Hastings Secondary College Upgrade | Port Macquarie Campus / Response to DPIE Request for Information

SINSW SSDA — REV 1 — 13/10/21

## **Additional questions and request for information:**

West Elevation

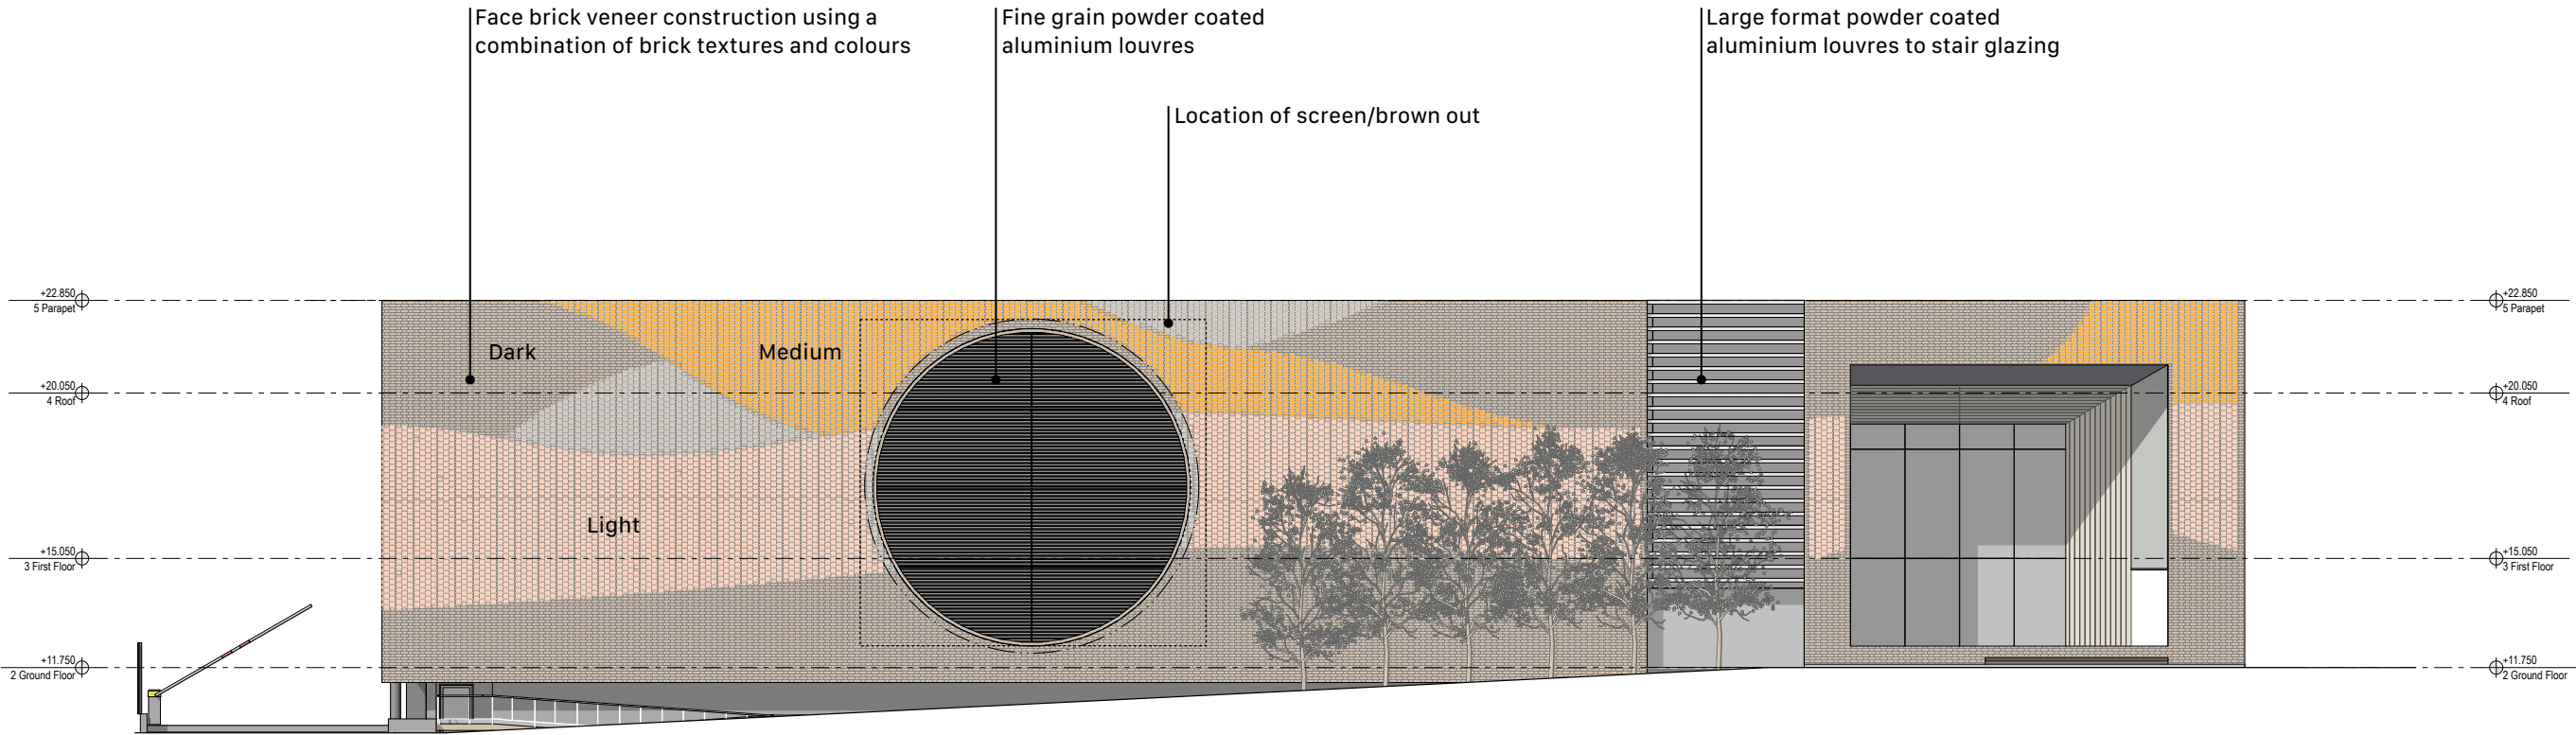
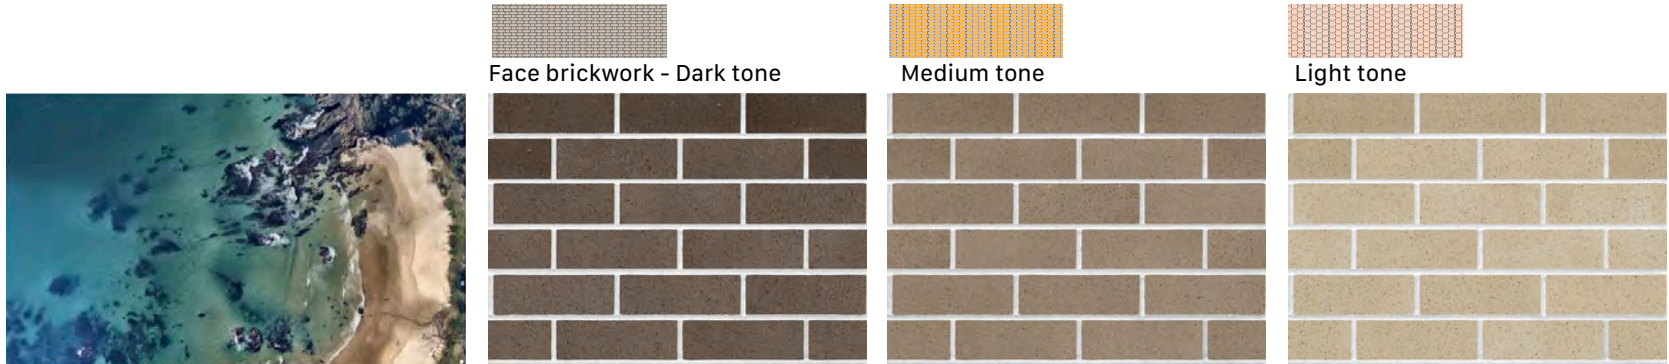
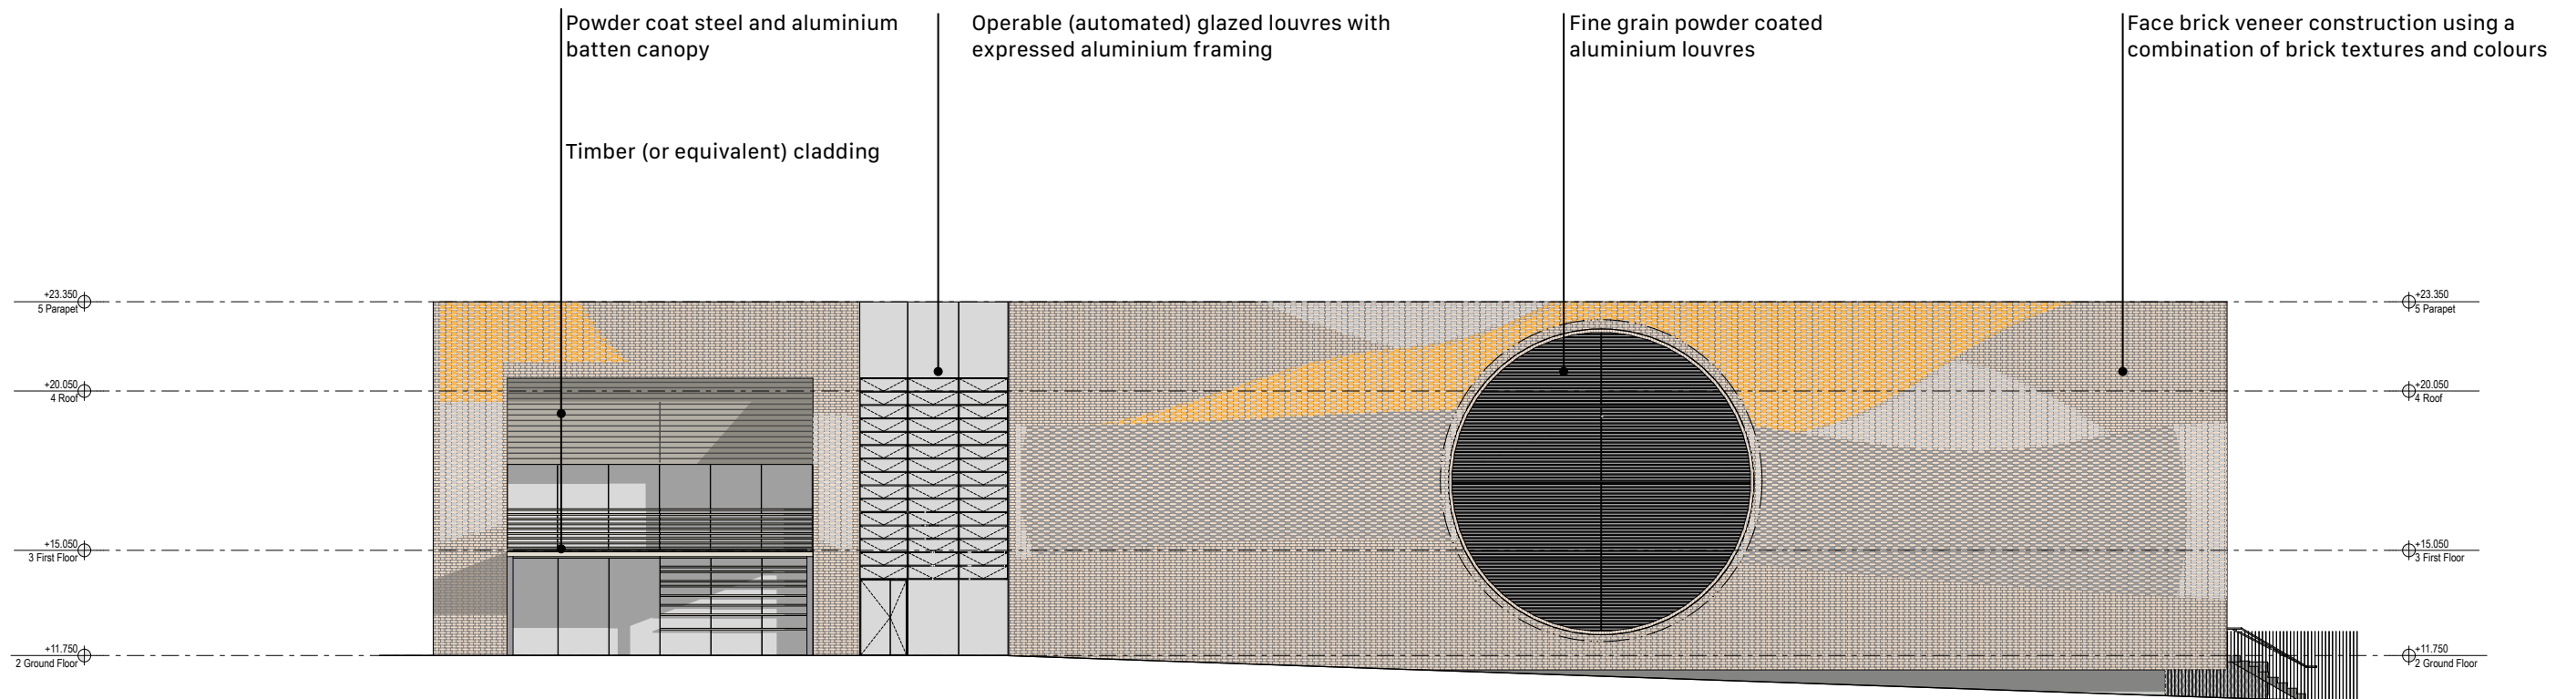
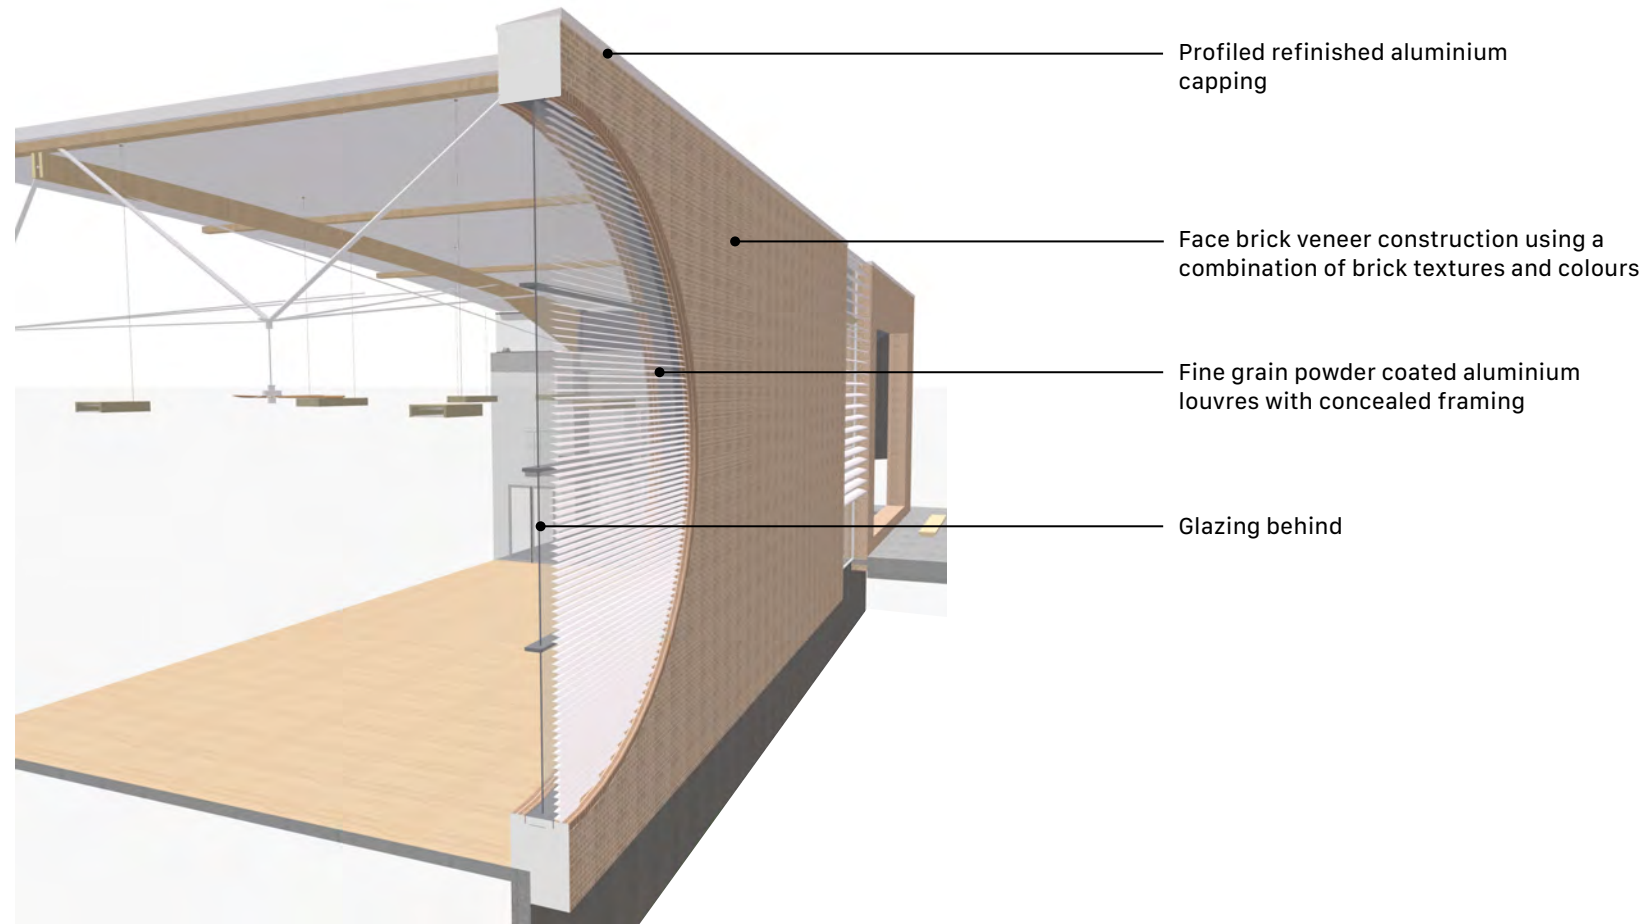
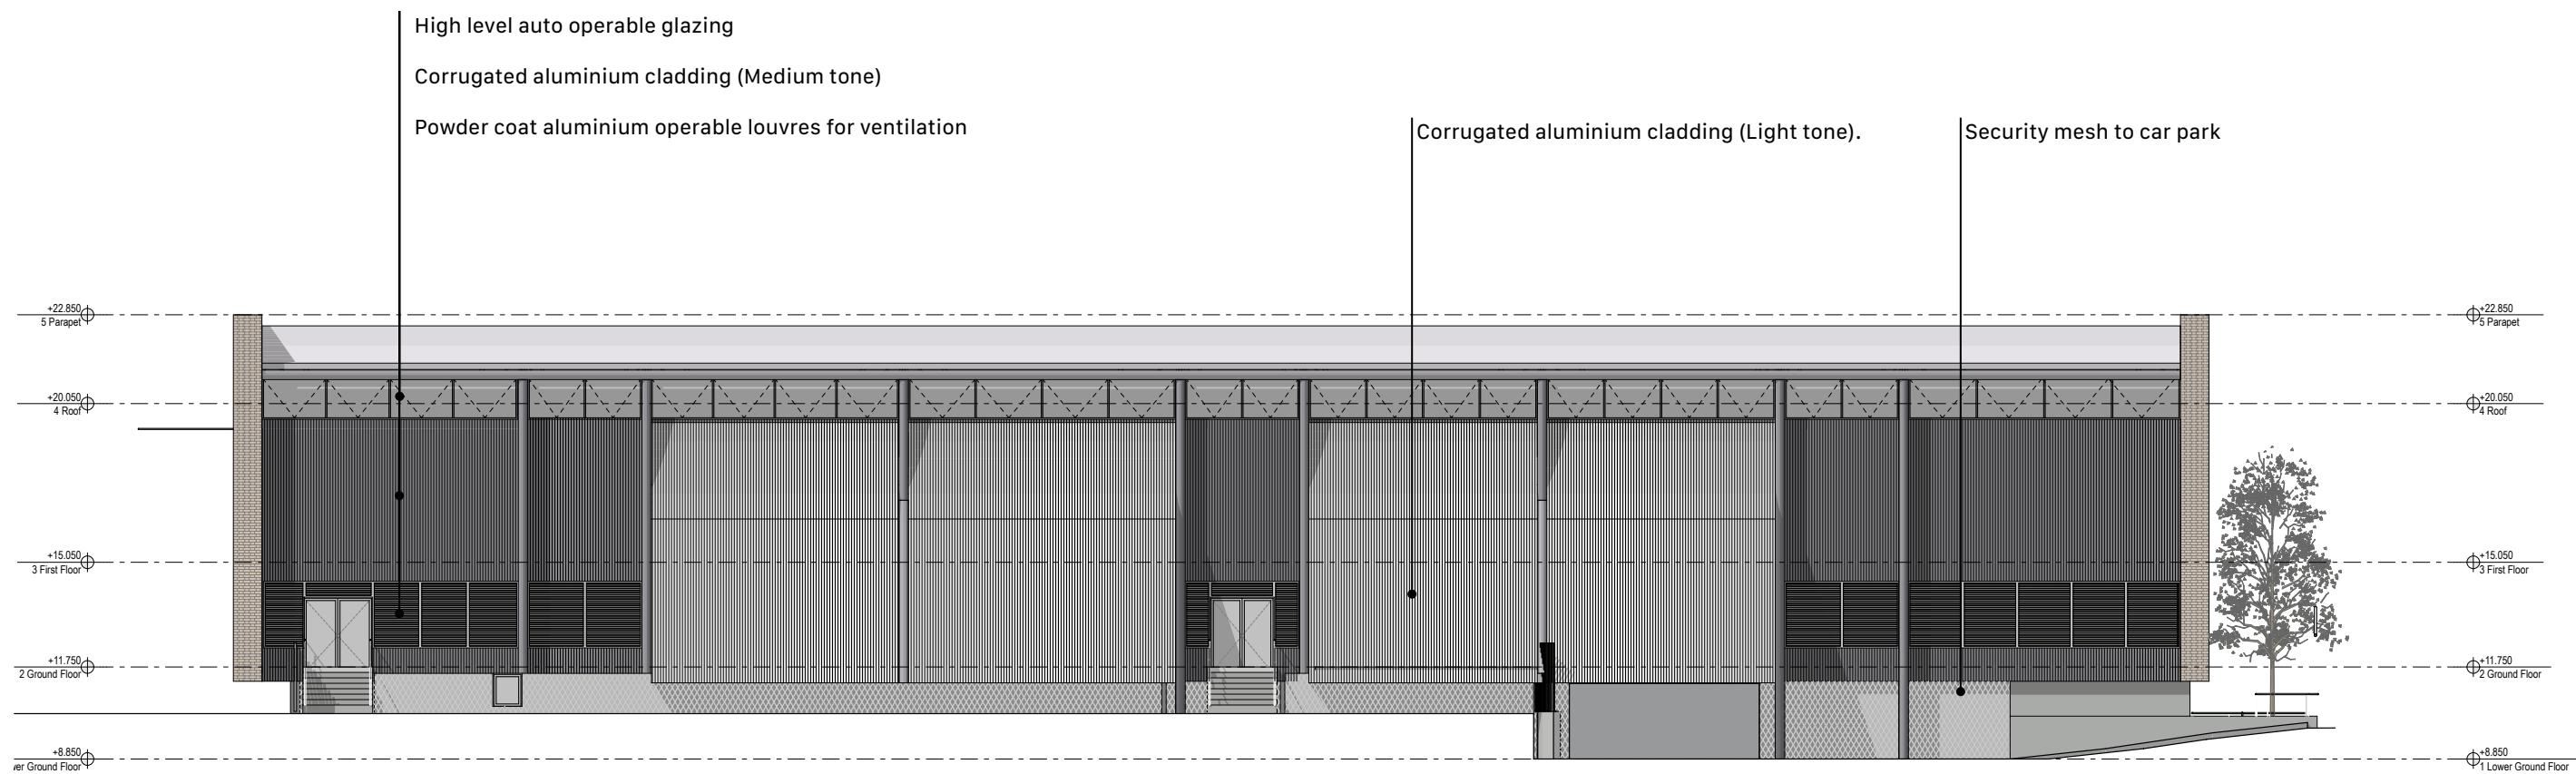
GANSW advice (dated 12th August 2021) recommended that detail be provided demonstrating how the extensive circular west facing aperture on the PCYC relates to place, in particular micro climate, thermal comfort and glare, and how it is envisaged to be protected from western sun. Sole reliance on high performance tinting or glazing is to be avoided.

The East and West elevations of the PCYC, SSDA-310200-Revision 04 indicates that the extensive circular east and west facing apertures consist of dark coloured performance glazing. It is recommended that alternative options for solar performance be investigated.

An additional layer of detail has been provided following on going design development to address the acoustic and thermal performance of the facades.

Circular window

To the west and east this window will be protected externally by fixed powder coated aluminium louvres. These louvres will be supported by a suppressed framing system so that the horizontality of the louvres remains the dominant feature. The window to the west is fixed glazing to address acoustic requirements but to the east has an

element of operability to meet the required 5% natural ventilation of all non air conditioned areas (Courts, Foyer and Circulation).

Internally the western window will have a projector screen which will also act as a brown out blind.

West/East Link

The west/east link is proposed to be experienced as a clear glazed link separating the courts and the support spaces. To maintain a high level of transparency a larger format external powder coat aluminium louvre is used to the west. Similar to the western circular window, the link glazing to the west is fixed. The link glazing to the east will be large format glazed louvres with expressed framing.
